**US Army Corps
of Engineers®**
New York District

**Integrated Hurricane Sandy
General Reevaluation Report
and
Environmental Impact Statement**

**East Rockaway Inlet to
Rockaway Inlet and Jamaica Bay**

**Appendix G
Public Engagement**

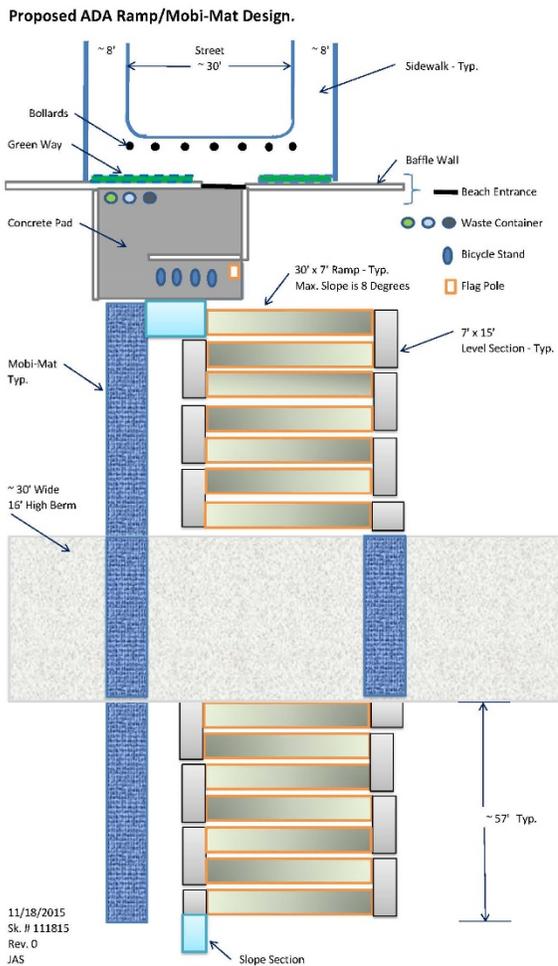
On the topic of ADA access to the beach from B126th to B149St, the attachment was previously sent on May 6th, 2016 to the USACE for future consideration. The proposal was also published in The Wave, Friday, May 13, 2016, page 54.

The sketch #111815 depicts how we could envision the beach entrances, the traversing over the 16 to 18 foot high dunes/berms and important accessories like Bicycle Stands, Trash Containers and Flag Pole. We have a unique opportunity to develop a world class project that NYC can be proud of.
